223 with 725.1 with ISA2 and M176 Harsh 3to4 Upshift

Topic number	LI27.60-P-080169
Version	1
Function group	27.60 - Gearshift, control
Date	2/11/26
Validity	BR223 with M176 engine and 725.1 (NAG3 Mopf) transmission with ISA2
Reason for change

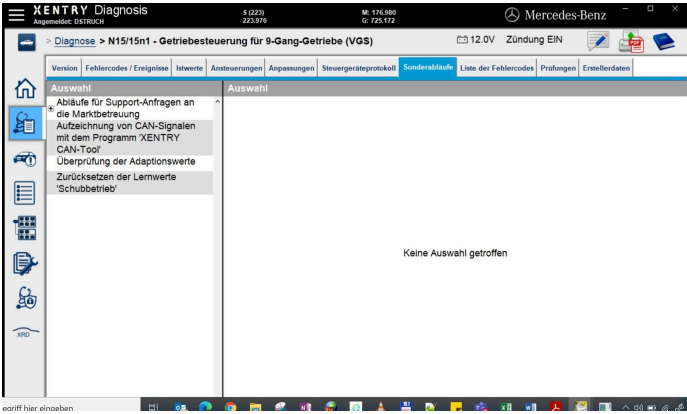
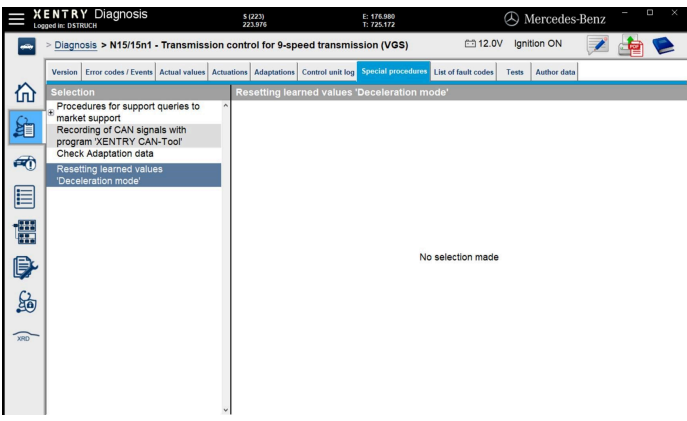
1. Perform IPR and follow the provided instructions.
2. Perform Special Function "Resetting of learned values 'Deceleration Mode'"
(VGS > Special Procedures > Special procedure > Resetting learned values Deceleration mode)
3. Complete the standstill adaptation

- Check VGS control unit log or eeprom .txt file for "Program Status"
